Introduction: line 33, does not seem enough to clarify how this paper relates to the 2 existing ones. Given that already 2 articles were published in the past, this is certainly something the reviewers will complain about if it is not corrected. I'd suggest making a clear sentence / small paragraph summarizing what was learned in the previous tests and how the results in this article add up to it.

Figure 1: Agreement data/mc for $Z = 5$ cm

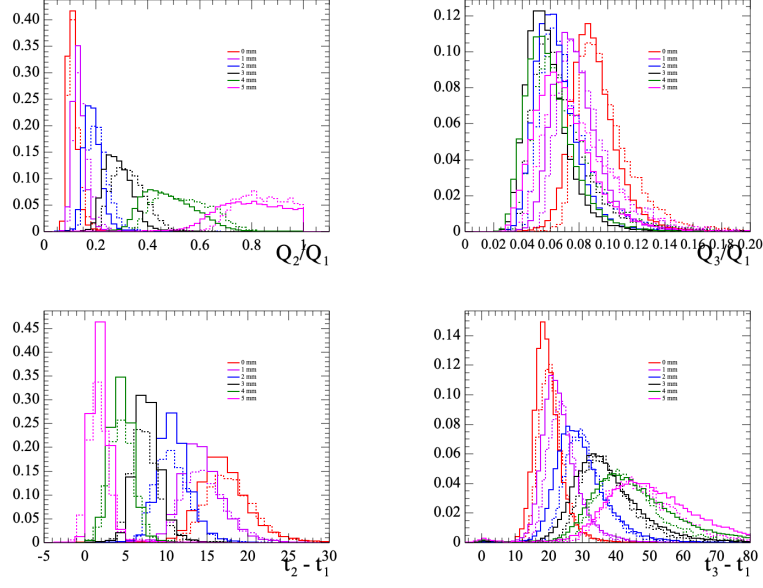
** Line 300 : "For this study we use tracks close to ERAM plane to minimize possible effects induced by long drift."

Here in this comparison, I understand the argument of line 300, but at the same time in real life we have 1m of drift and we know that at the end the diffusion and the charge spreading are completely correlated and are responsible of the WF we observe. Can you show the same comparison for another value of the drift , will the RC value obtained be compatible with the one shown here?

Please find different comparison at different drift distance in Fig. 1, 2, 3. In general the agreement is better at larger drift distances. Notice that by doing a comparison with MC with RC = 55 we get plots in Fig. 4. Some plots have been added to the paper

Figure 5: Fit with pol1 and with sqrt(z) for data(left) and MC (right)

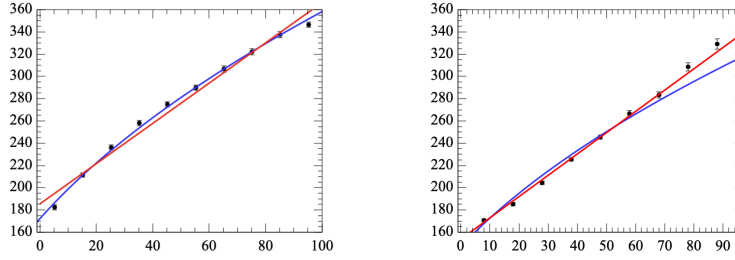
** Figure 23: why don't you fit with formula number 7? I think it is important. We need also to know what is the resolution at the mesh and the number of effective electron Neff By eye, I have the impression that the simulation is more linear with strange behavior at low drift. and this can be confirmed by the fit

Yes this is true. Please find in Fig. 5 the fit with pol1 and Eq.1 for data and simulation. We added a sentence saying that we observe this effect but for now it is not understood.
